February 10, 2010
U7-C-STP-NRC-100036

South Texas Project
Units 3 and 4
Docket Nos. 52-012 and 52-013
Response to Request for Additional Information

Attached are the responses to the NRC staff questions included in Request for Additional Information (RAI) letter numbers 299 and 302 related to Combined License Application (COLA) Part 2, Tier 2, Sections 3.7.1, 3.7.2 and 3.8.4.

Figure 3H.6-15: SASSI2000 Model of UHS and RSW Pump House

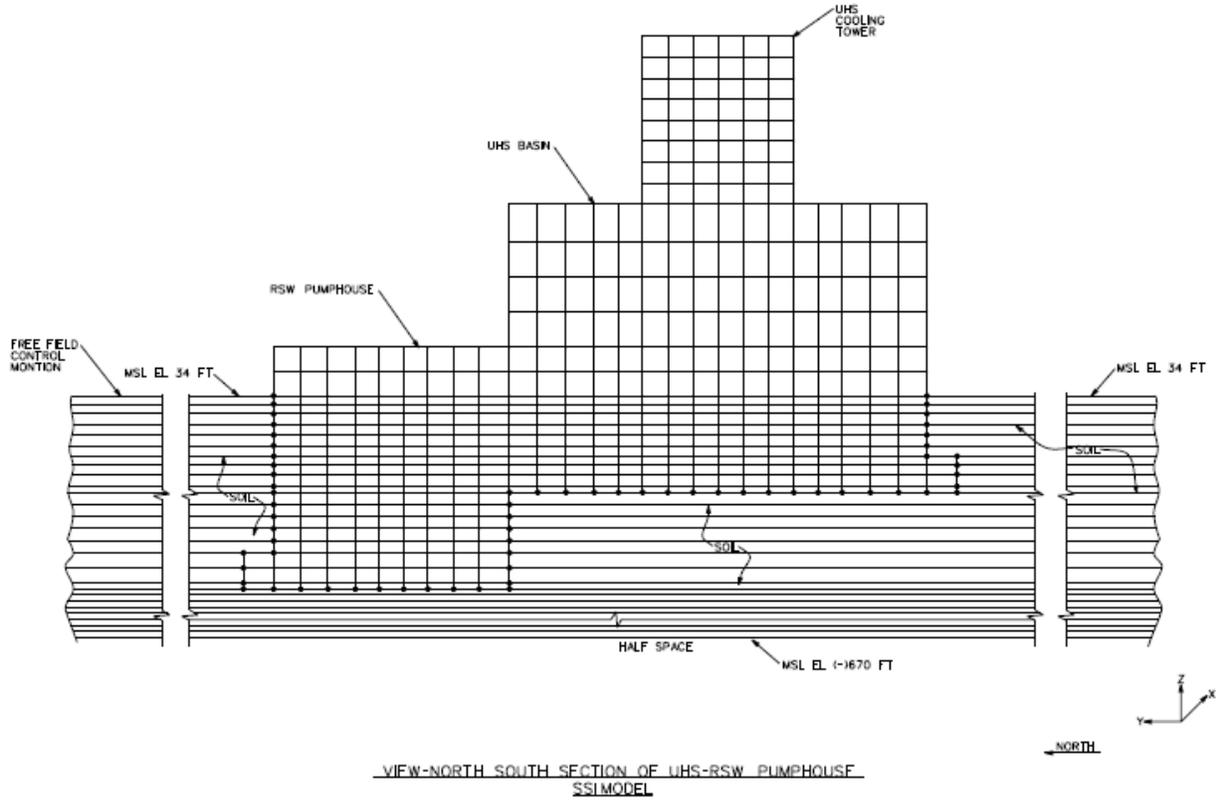
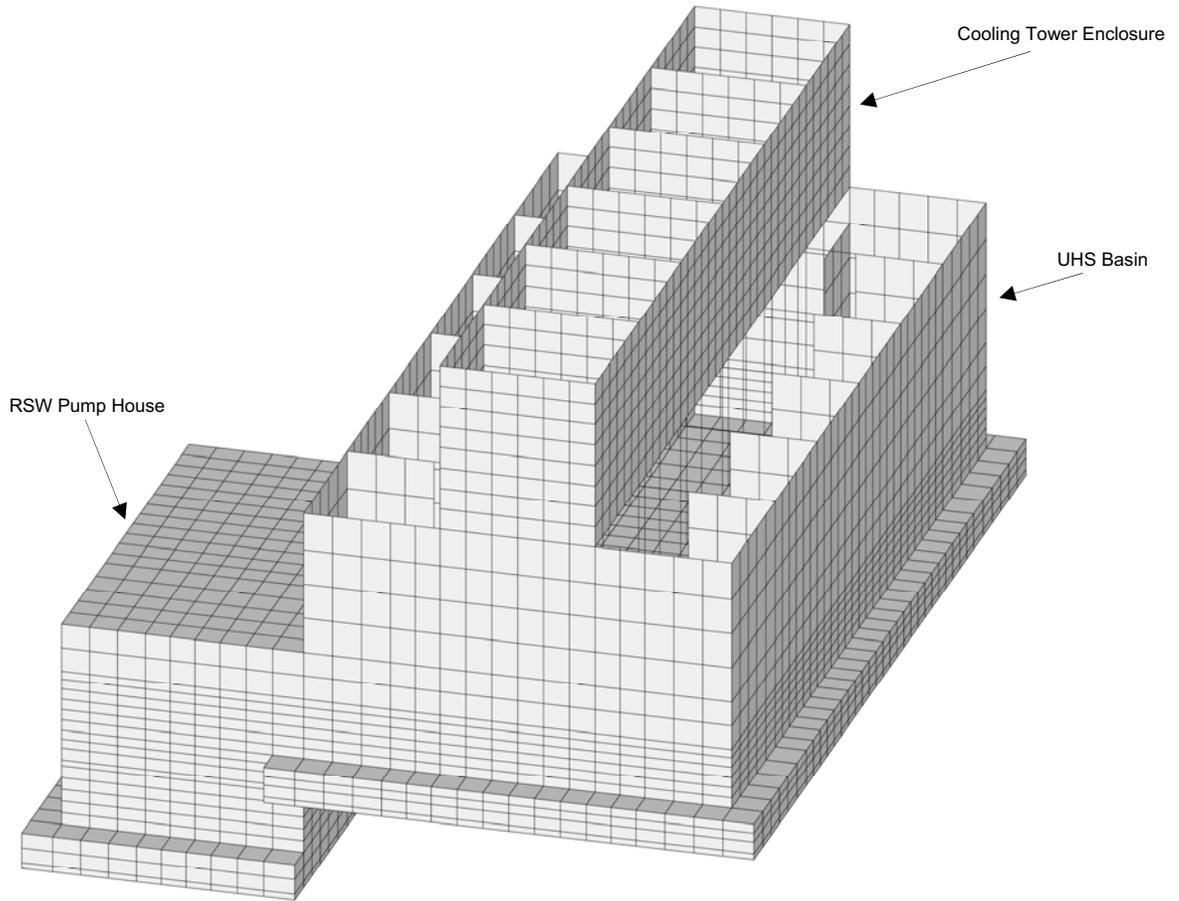
7. A figure showing the finite element model of the structure in relation to the layered soil system.
8. A description of how the ground water effects were treated in the SASSI2000 model.

7. Figure 3H.6-15 showing the north-south cross-section of the three-dimensional finite element model of both structure and soil layers was provided as part of the Supplement 1 response to RAI 03.07.01-13 (see letter U7-C-STP-NRC-090208, dated 11/19/2009) and for convenience was reproduced in part 3 above. For additional information and figures, please see the response to RAI 03.07.02-16 submitted concurrently with this response.

Figure 3H.6-138: Broadened Horizontal FRS for RSW Piping Tunnels

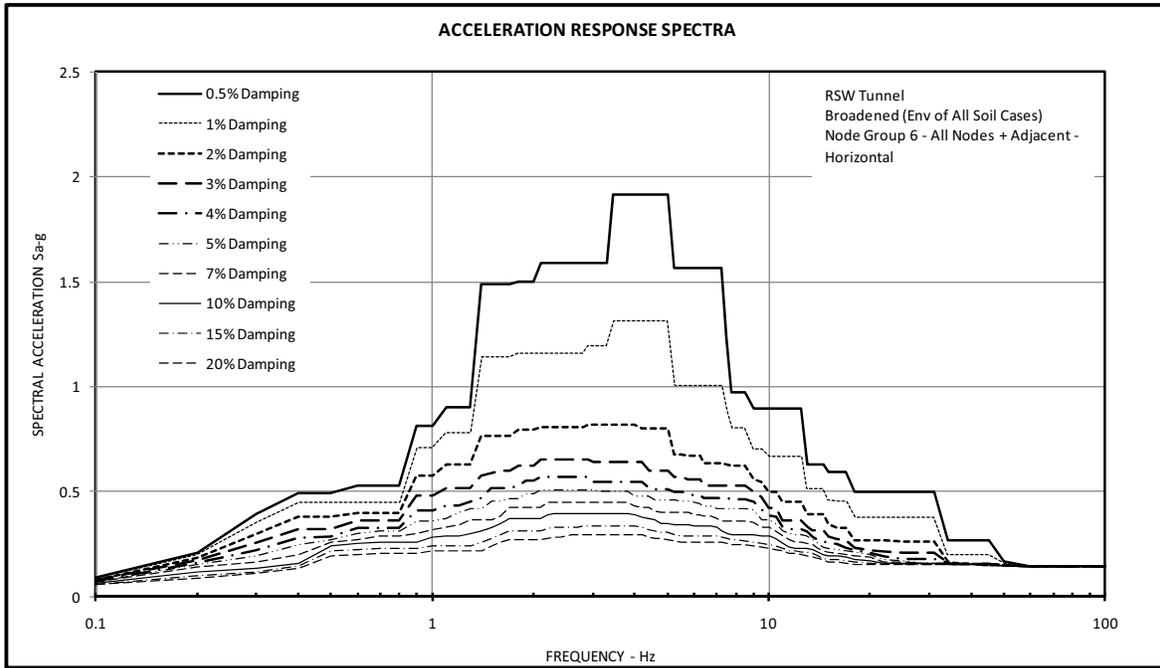
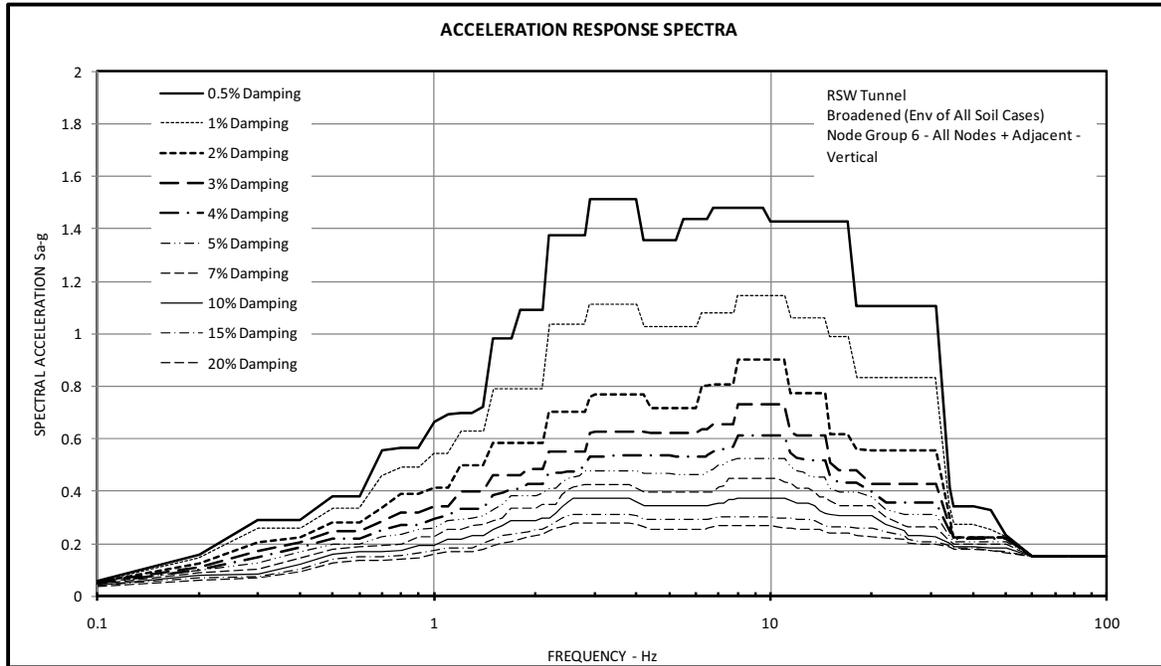
1. A description of the equivalent static analysis method used for the RSW piping tunnel.
2. A description of how the seismic and static loads were calculated and applied to the model. Show the model and boundary conditions including the soil springs used in the analysis.
3. A description of the type of strains (tensile or compression) were calculated in the RSW piping tunnel.
4. A description of how both axial strain and transverse shear demands were considered in the analysis of the RSW piping tunnel.
5. A description of how the concrete elements of the RSW piping tunnel were determined to be rigid so that there are no in-structure amplifications.
6. Describe the SSI analysis from which the accelerations are obtained to establish the SSI forces for the analysis of the RSW piping tunnel (see the last bullet in Section 3H.6.6.2.2).

In order to quantify the in-structure amplification and ensure that the use of 0.21g ZPA adequately accounted for in-structure amplification, a two-dimensional SSI analysis of the RSW tunnel is performed. Attached Figures 3H.6-138 and 3H.6-139 show the resulting amplified response spectra for all the walls and slabs of the tunnels. As can be seen from these figures, the amplified ZPA of these response spectra are less than 0.21g ZPA acceleration used for the design of tunnels' walls and slabs.

Figure 3H.6-40: SAP Finite Element Model for UHS and RSW Pump House Design

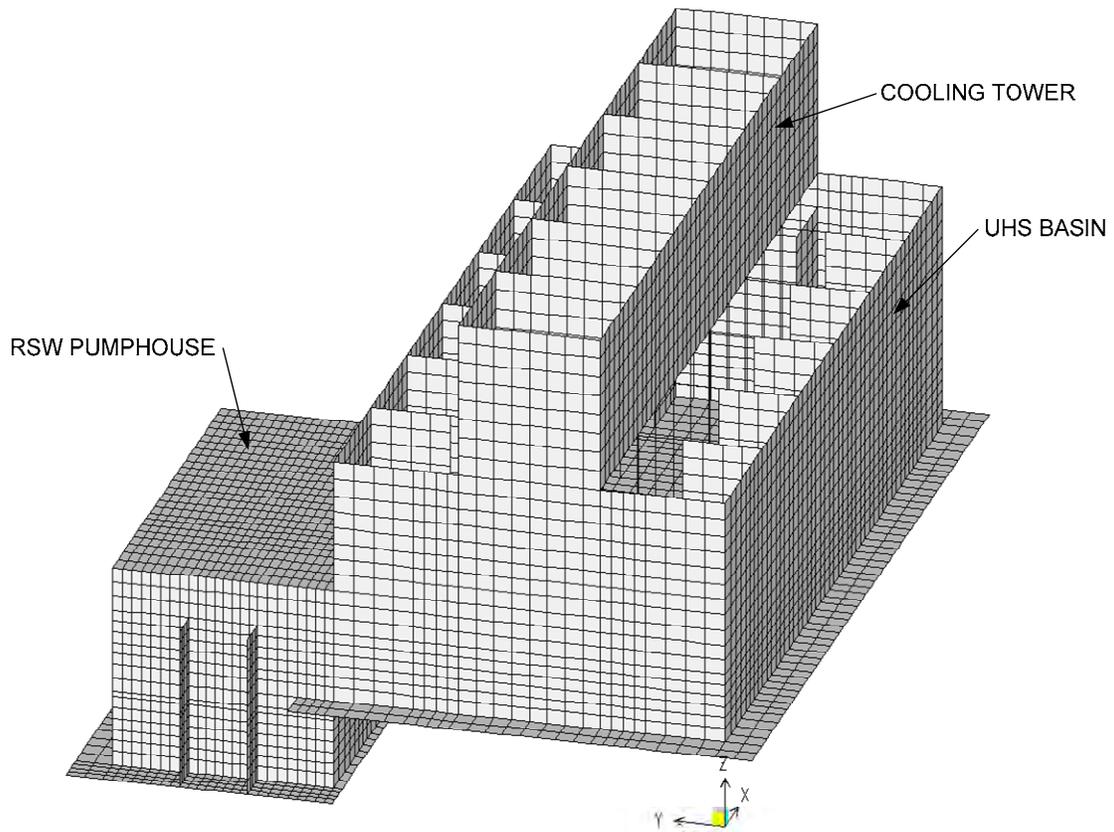
1. In the response to Item 2 of RAI 03.07.01-4, the finite element model of the UHS basin and RSW Pump House was not provided in Figure 3H.6-40 (this figure was supposed to be part of the response to RAI 03.07.01-13). The applicant is requested to ensure this information be part of Figure 3H.6-40, including a plot showing the basement slab and soil-retaining wall mesh configuration and grid sizes. The response to Item 2 of RAI 03.07.01-4 also states that, ***“The model mesh size is detailed enough to model the principal features of the structure and transmit a frequency of at least 33 Hz.”*** The applicant is requested to a) provide the criteria and quantitative basis to show that the element sizes are sufficiently small to transmit frequencies of up to 33 Hz for the three soil cases; and b) provide a justification that the aspect ratio of the elements is sufficiently small as not to affect the solution accuracy.

1. Figure 3H.6-40 has been provided as part of the Supplement 1 response to RAI 03.07.01-13 (see letter U7-C-STP-NRC-090208 dated 11/19/2009) and for convenience is reproduced below. Note that this figure provides the Finite Element Model (FEM) used for design of the ultimate head sink (UHS) and reactor service water (RSW) pump house. In this FEM, the basemat is represented by shell elements, whereas in the FEM model for the soil-structure interaction (SSI) analysis (see Figure 3H.6-15a) the basemat is represented by solid elements. Solid elements are required for proper modeling of interaction between the soil and the structure in the SSI analysis.

Figure 3H.6-137: Formulations Used for Calculation of Factors of Safety Against Sliding and Overturning

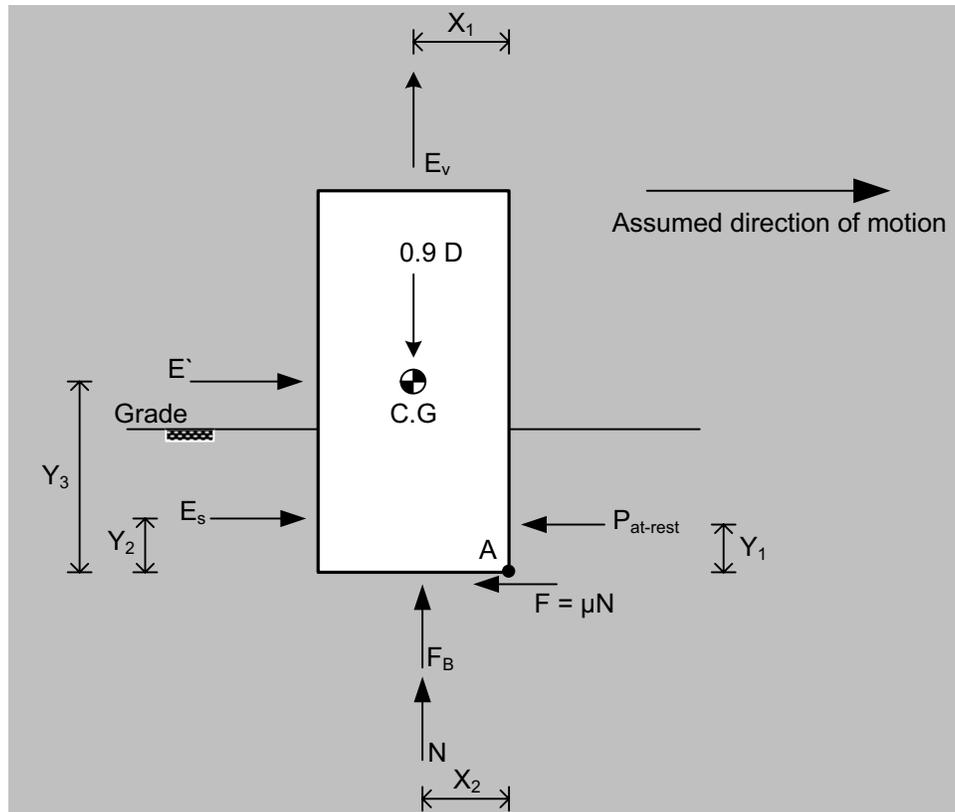
4. In the seventh and last bullet of the response to RAI 03.07.02-10, Figure 1 attached to this response shows the driving force "Es" as static and dynamic soil pressure but does not clarify the nature of the static soil pressure. The applicant is requested to clarify the nature of the driving static soil pressure in Figure 1. Also, please clarify how total at-rest soil pressure is calculated including algebraic expression. This figure with the above clarification should be included in the FSAR.

As requested, Figure 1 of the response to RAI 03.07.02-10 will be included in COLA Part 2, Tier 2 as new Figure 3H.6-137; see attached COLA mark-up.
